Urgent Field Action Notice for the Cryostat Devices

March/2019

Positioning Symbol „Flammable freezing sprays prohibited“	Device
	Leica CM1950

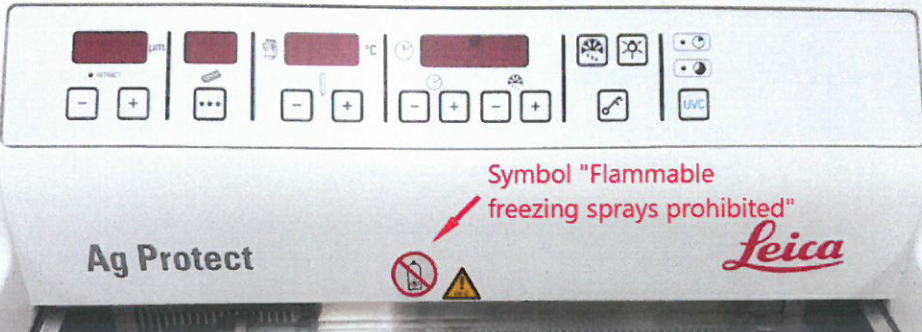
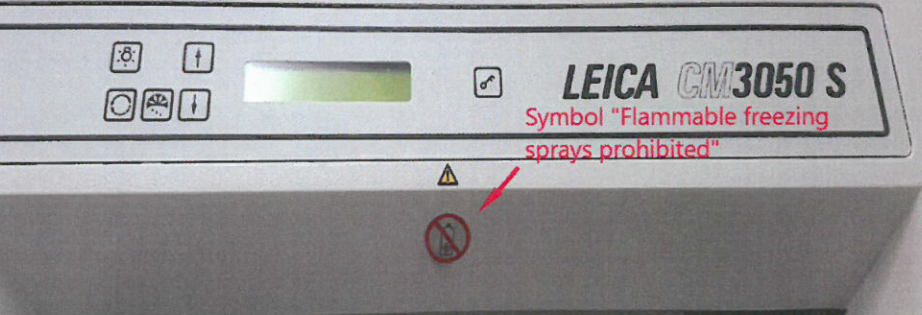
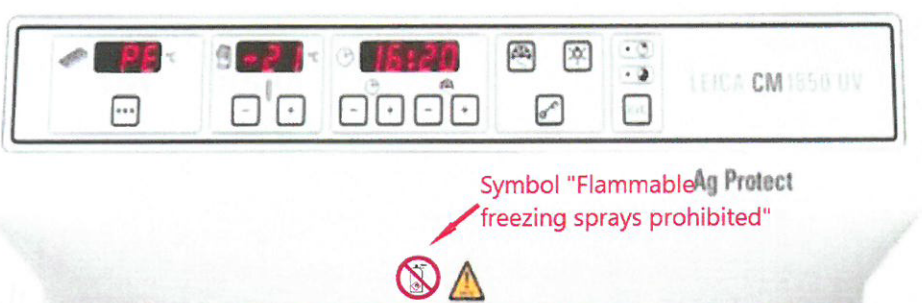
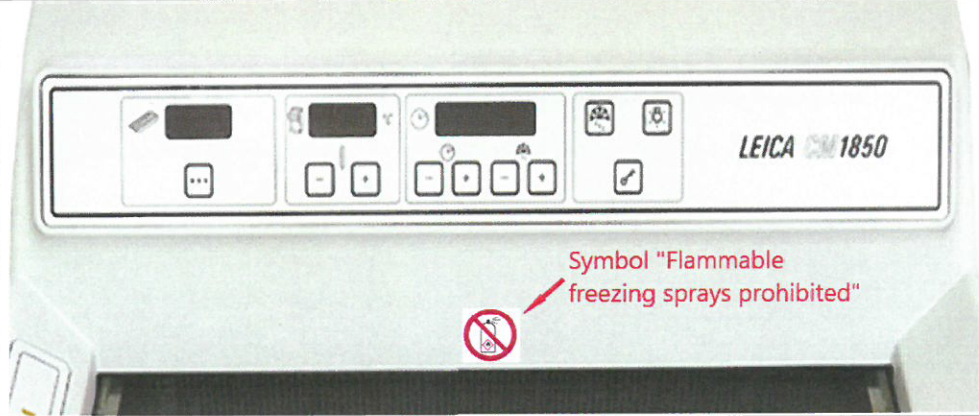
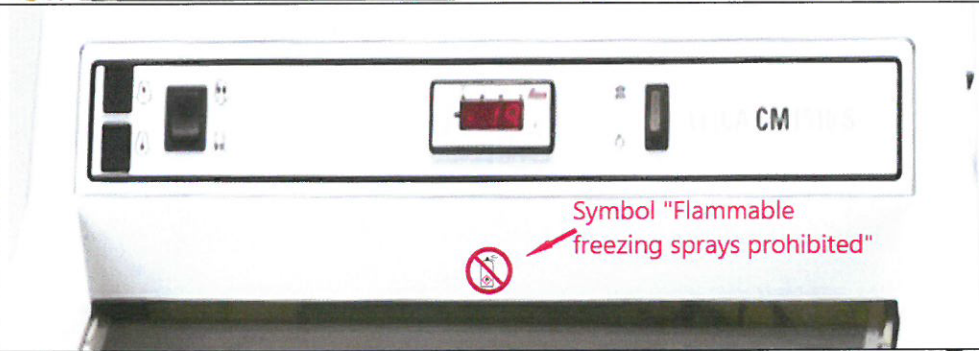
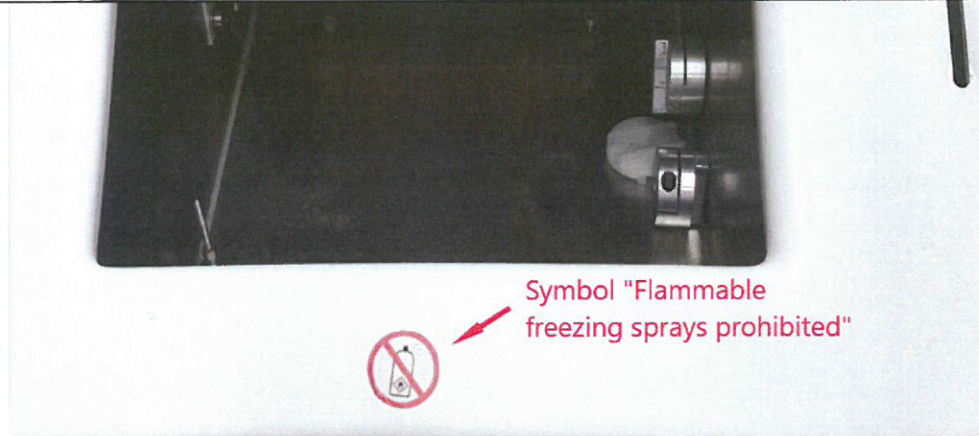
As part of our post market surveillance, we recognized that some customers are using flammable freezing sprays within the cryostat chamber. All flammable freezing sprays can potentially ignite and therefore can cause serious injuries. The risk should be indicated on the labelling of these sprays. The current cryostat labelling, however, does not include any specific warning about usage of flammable freezing sprays. As part of this Field Action we are going to improve the labelling on the affected devices.

As an immediate action, we ask you to improve the labelling with the attached adhesive label as shown below

First clean the surface around the area where the adhesive label shall be placed (grease free). Then remove the provided adhesive label from the foil and place it on the surface as shown in the pictures below.

<p>Symbol "Flammable freezing sprays prohibited"</p> <p>Ag Protect</p> <p>Leica</p>	<p>Leica CM1860UV</p>
 <p>Symbol "Flammable freezing sprays prohibited"</p> <p>Ag Protect</p> <p>Leica</p>	<p>Leica CM1520/ Leica CM 1860</p>
 <p>Symbol "Flammable freezing sprays prohibited"</p> <p>LEICA CM3050 S</p>	<p>Leica CM3050 S</p>
 <p>Symbol "Flammable Ag Protect freezing sprays prohibited"</p> <p>LEICA CM1850 UV</p>	<p>Leica CM1850 UV</p>

<p>Symbol "Flammable freezing sprays prohibited"</p>	<p>Leica CM1850</p>
 <p>Symbol "Flammable freezing sprays prohibited"</p>	<p>Leica CM1510 S</p>
 <p>Symbol "Flammable freezing sprays prohibited"</p>	<p>Leica CM1100</p>
